New THOR-50M Molded Shoe

472-7800-1 and 472-7800-2

Publication Date: January 2017

Figure 1 - New Molded Shoe Construction

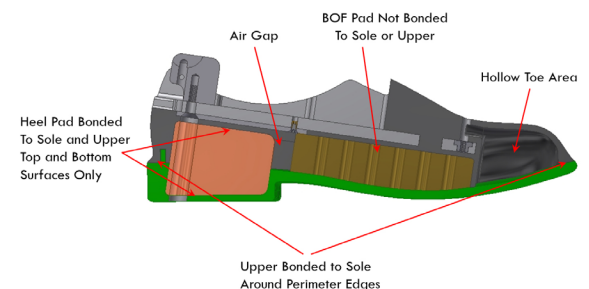
The new molded shoe's construction consists of a urethane upper shell with a carbon fiber foot bone resting upon a bonded heel pad and a ball of foot pad encased with a bonded sole (Figure 1).

Figure 2 - THOR-LX Leg length and resting angle

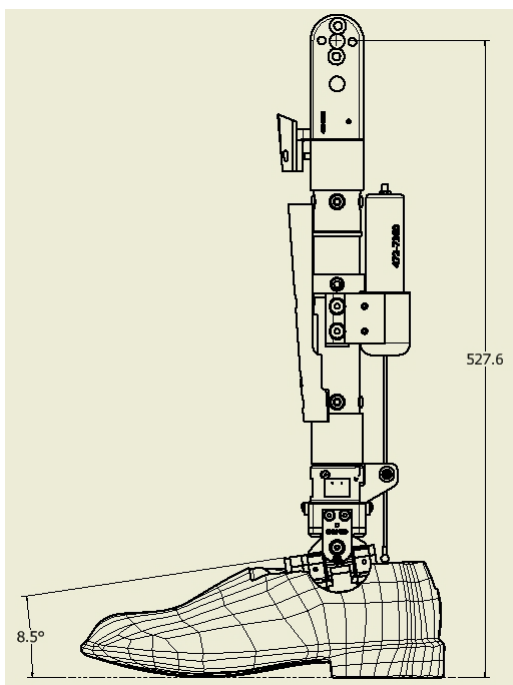
- The previous molded shoe is approximately 1 inch shorter in height, which makes the overall knee to heel length longer when installing the new version (Figure 2).

- The resting angle of the new molded foot bone in relation to the ground is approximately 8.5 degrees, which matches closer to the foam foot and mil-spec shoe. The old molded shoe foot bone is parallel to the ground when resting on the floor.
- New test procedures are required (NQP AUG 2016). *The tests in the 2015 draft NHTSA Qualifications manual are for use with the foam foot and mil-spec shoe only.

Figure 3 - THOR-LX compliant bushing and dorsi-plantar stop

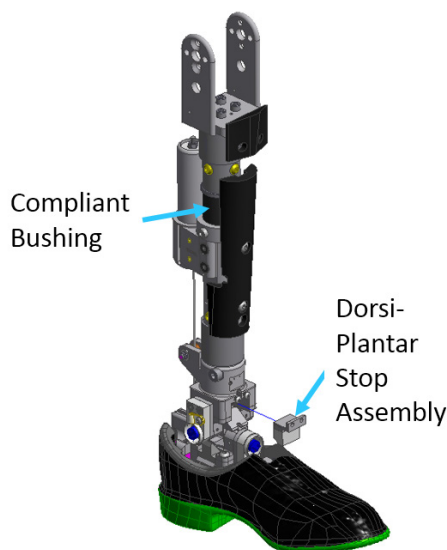
In order to certify the leg with the new molded shoe, changes to the compliant bushing and dorsi-plantar stop assembly are required (Figure 3). The stiffness of the compliant bushing in the leg has an effect on the heel of foot performance and the stiffness of the dorsi-plantar stop assembly has an effect on the ball of foot performance.

Complete tibia compliant bushing assemblies can be purchased and replaced in the leg (Figure 4). Existing assemblies can be reworked by removing and replacing the rubber element that is bonded between the flange and plunger that secure it into the leg. Due to the cost of the fixture and labor involved in the rework of the parts, Humanetics offerings a kit that includes the Molded Shoes, Complaint Bushing Assembly and Dorsi Stop Assemblies.

New dorsi-plantar stop assemblies can be removed and bolted directly into place.
